**SAN ANTONIO WATER SYSTEM
CENTRAL WATER INTEGRATION PIPELINE
MALTSBERGER PUMP STATION IMPROVEMENTS
SAWS Job No. 18-8617
SAWS Solicitation No. CO-00190**

**ADDENDUM No. 4
August 31, 2018**

E-2352

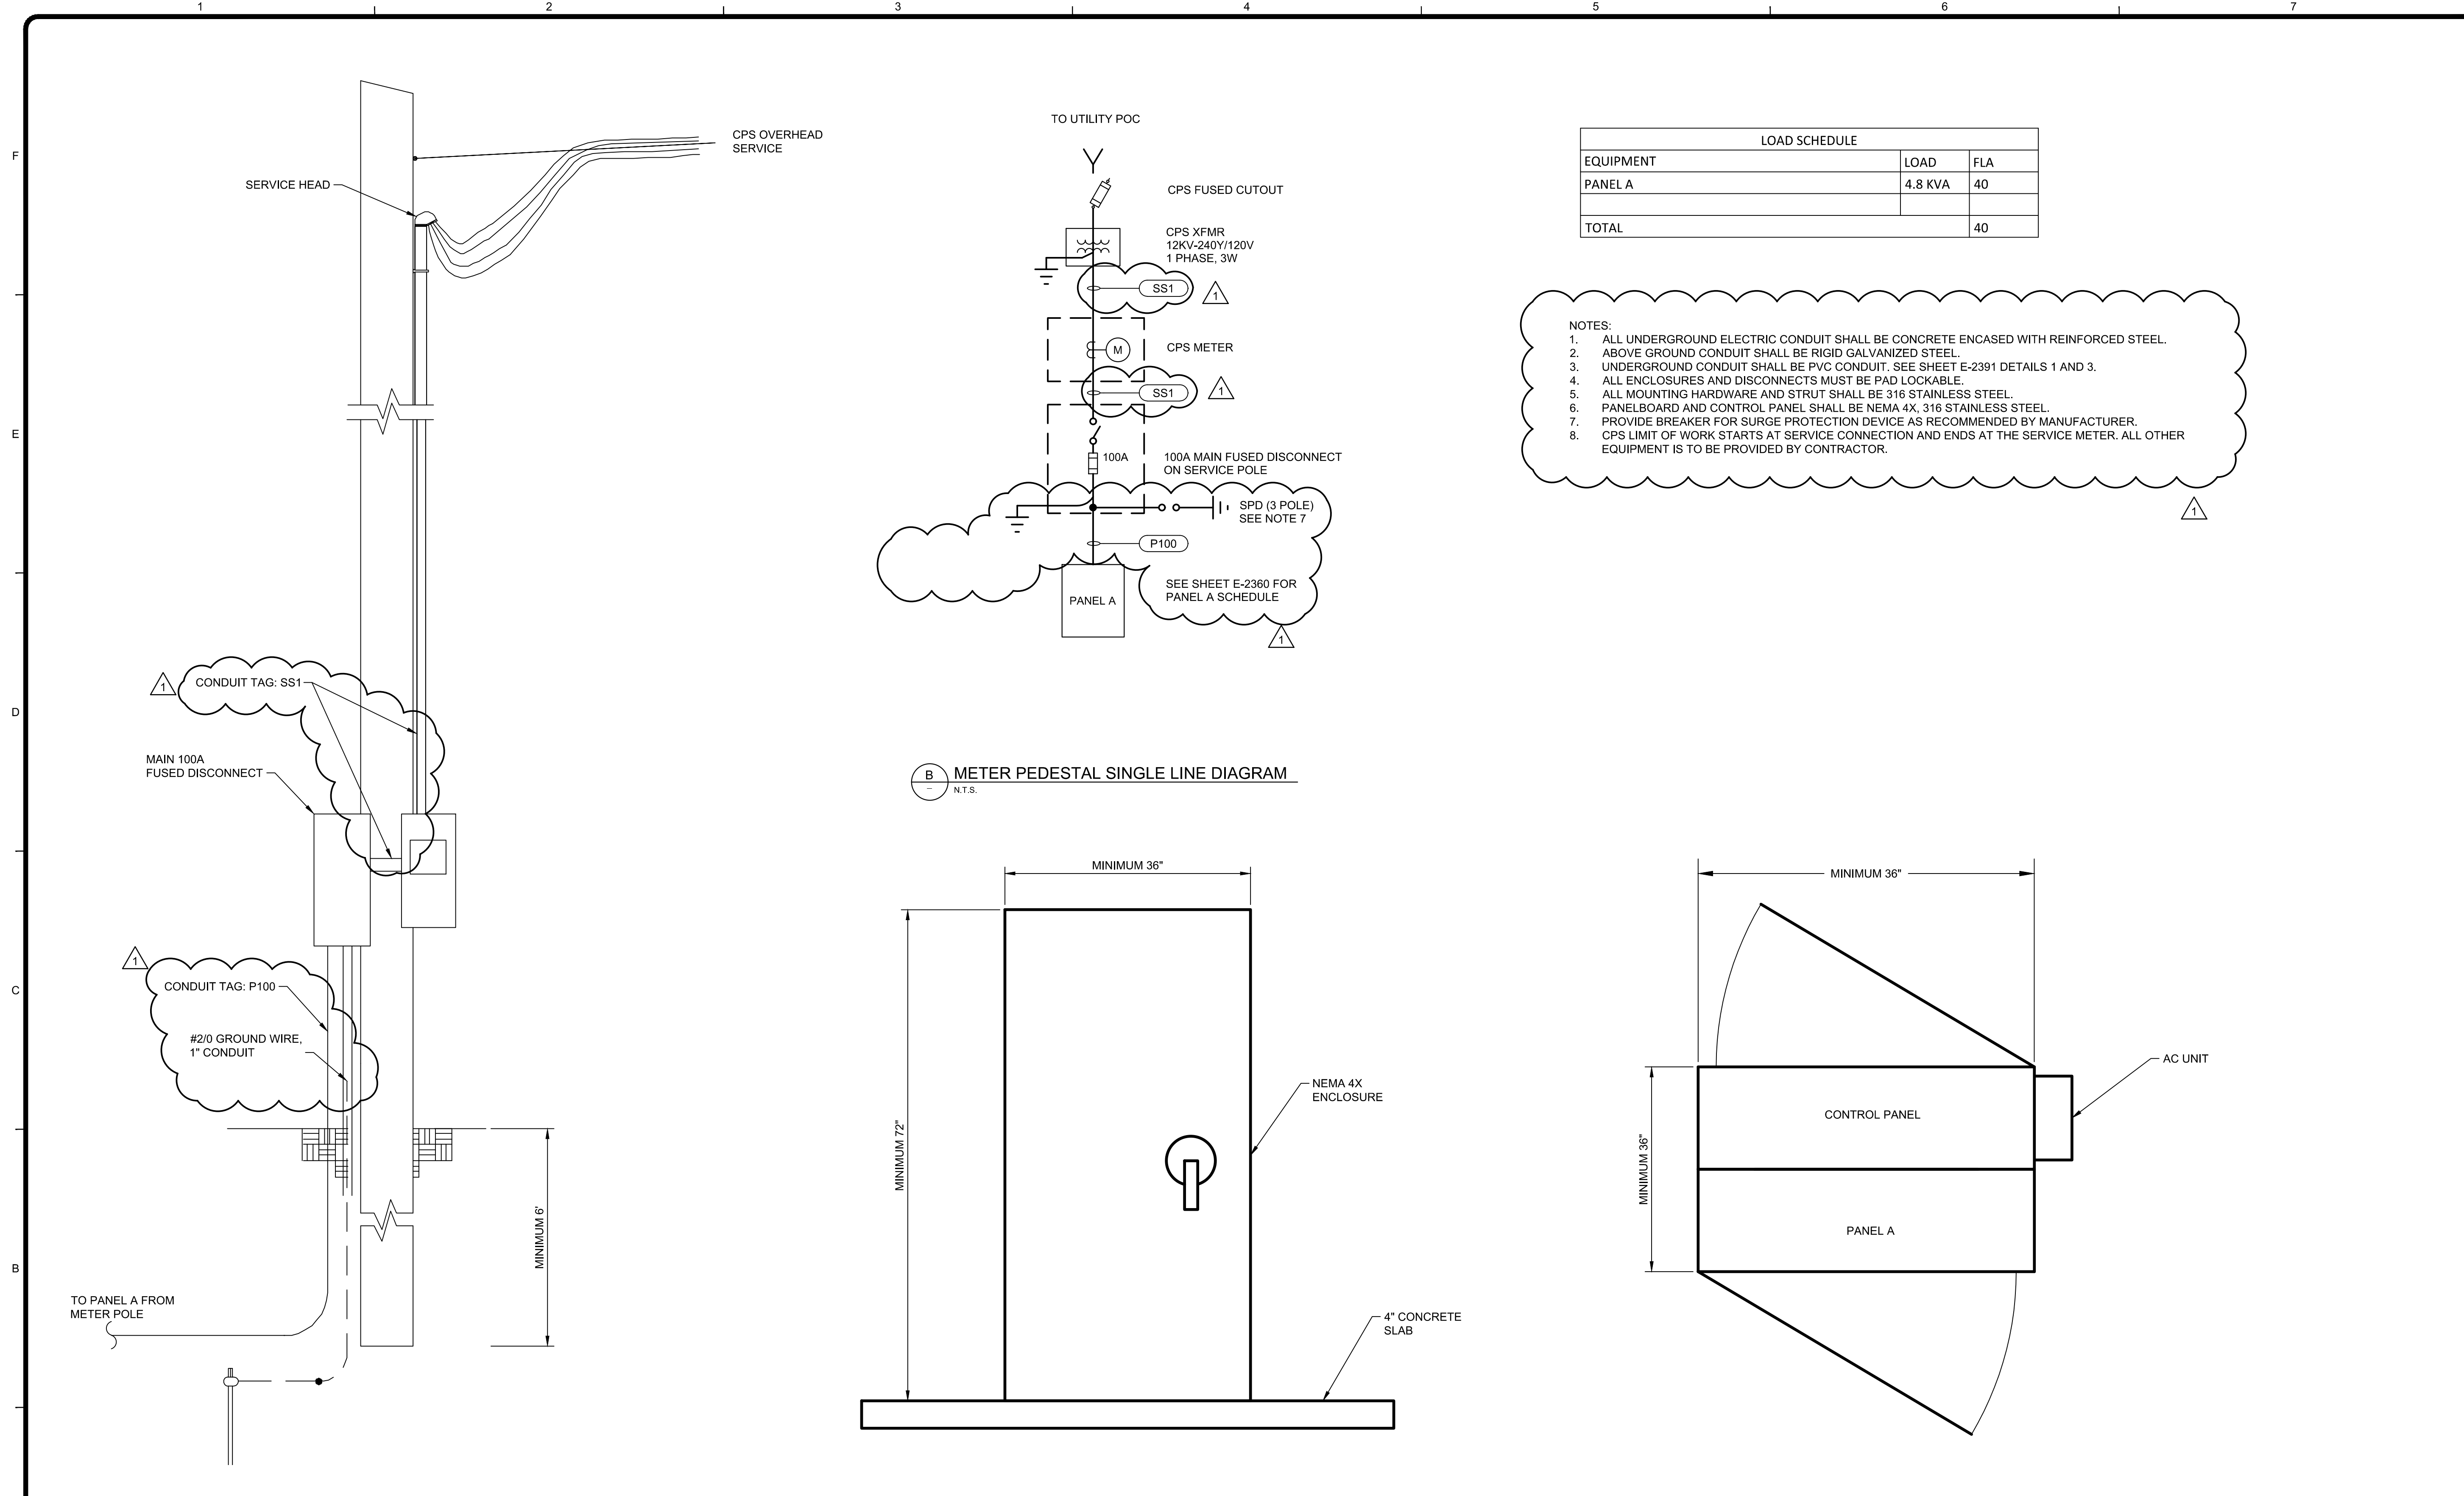
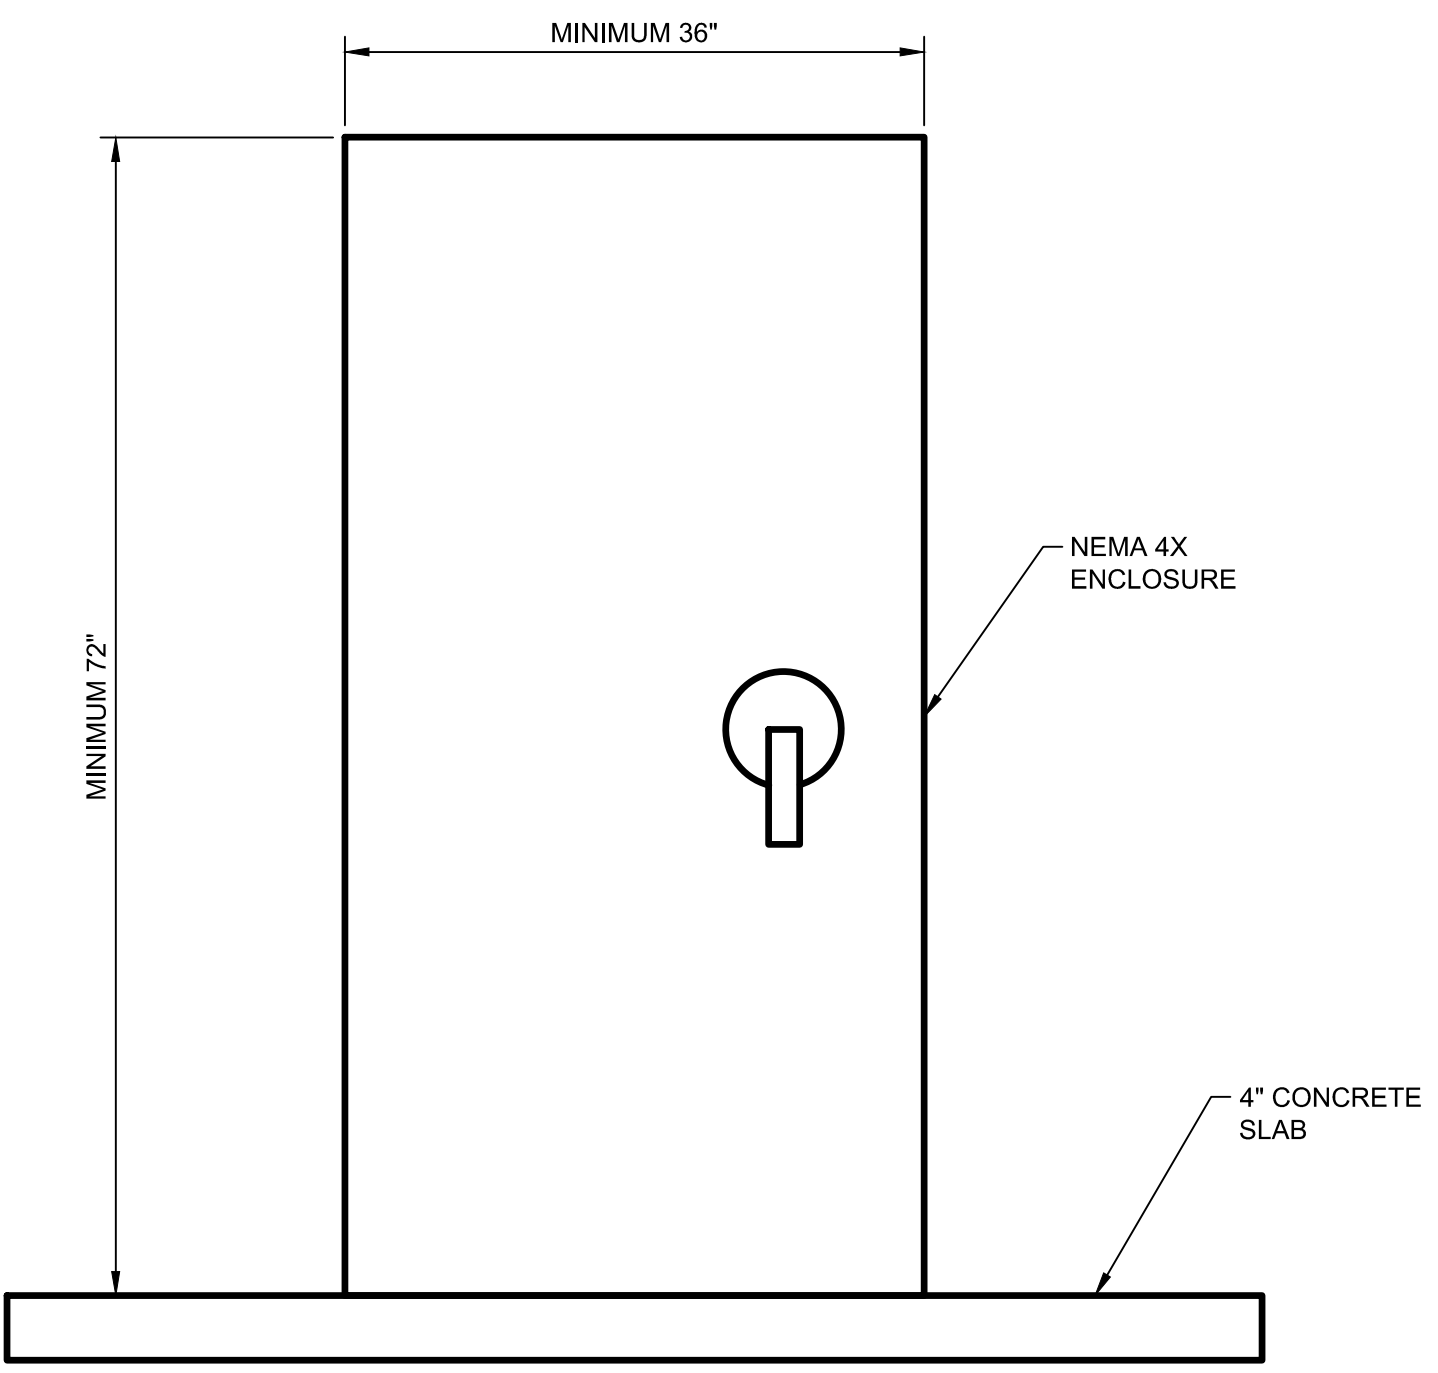
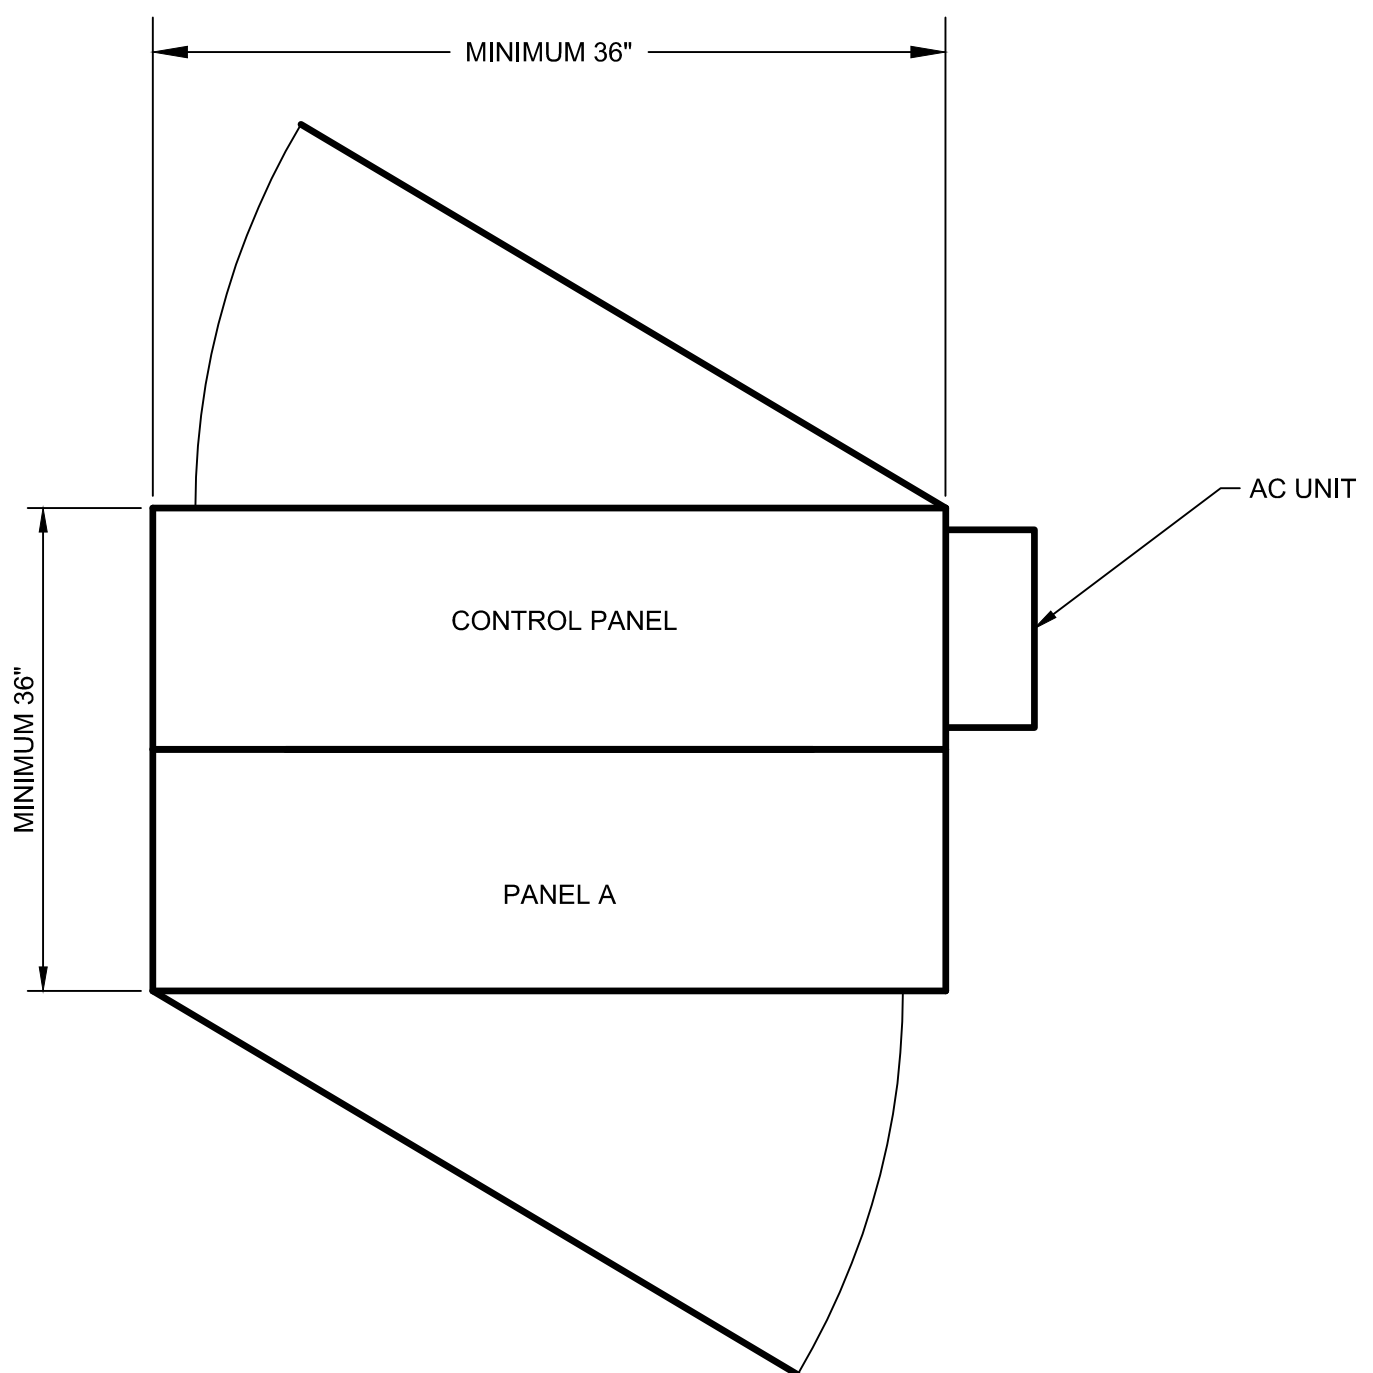
46	Sheet E-2352: Please identify all raceways with conduit tags so we may reference the conduit schedule accurately.	Refer to updated SHEET E-2352 per Addendum No. 4.
47	Sheet E-2353: Please identify equipment and instrumentation and provide a revised conduit schedule that accurately shows the "from-to". Example, conduit "P003" per the conduit schedule goes from "panel A" to "pressure trans panel. "P003" on Sheet E-2353 does not go to a panel, it is shown in the vault.	Conduit schedule has been revised. This is reflected in the changes to SHEET E-2360 per Addendum No. 4.
48	Sheet E-2353: Please provide a conduit schedule showing ALL conduits and their respective source and destination points.	Refer to updated SHEET E-2353 per Addendum No. 4.
49	Sheet E-2355: For panel "A" it says to see sheet E-2805 for panel "A" schedule. There was no sheet E-2805 provided. Please revise.	Reference has been updated to SHEET E-2360. This is reflected in the changes to SHEET E-2352 per Addendum No. 4.

62	Refer to plan sheets E2351, E2352, 2353 add a general note to refer the Contractor to the conduit schedule on plan sheet E2360.	Refer to updated SHEET E-2351, E-2352, E-2353 and E-2360 per Addendum No. 4.
63	Refer to plan sheet E2351 and E2360, the conduit schedule indicates tag SS1 as the feeder from the utility to the proposed panelboard A. However conduit run tag SS1 does not appear on the PRV-II site plan E2351, and we need to know the location of the utility connection.	Refer to updated SHEET E-2351 and E-2360 per Addendum No. 4.
64	Refer to the power pedestal elevation details on plan sheets E2352 (PRV-II site) and E2355(PRV-III site), also detail 7 on plan sheet E2395. These panels are a special custom manufactured product that are equipped with internal time clocks, lighting contactors, fluorescent lighting, etc, and are not applicable to the specification section 16470 (panelboards) in the bid spec set. Please provide us with a specification for these custom unmetered pedestal panelboards.	Power pedestal panel is not required on this project. Detail 7 on SHEET E-2395 is deleted per Addendum No. 4.
